ACS880 SLEWING CONVERTER MESSAGE AFE1 AFE2 (OFF2) / FIP CARD

TA 19-149

Service bulletin:

Crane family: GMA/GME

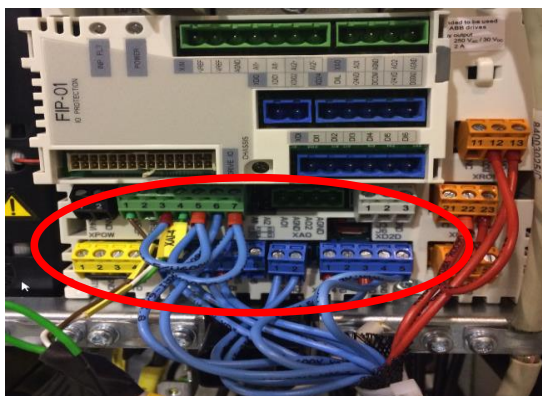
After replacement with an ACS880 drive AFE1 / AFE2 (off2) messages appear

Bypass the FIP01 card:

1/ Disconnect the green and blue terminals of the card FIP01

2/ Disconnect completely the bundle between FIP and Drive cards

3/ Connect the green and blue terminals directly on the drive card

4/ If the fault remains or if the fault is present without FIP card, do the shunt below.
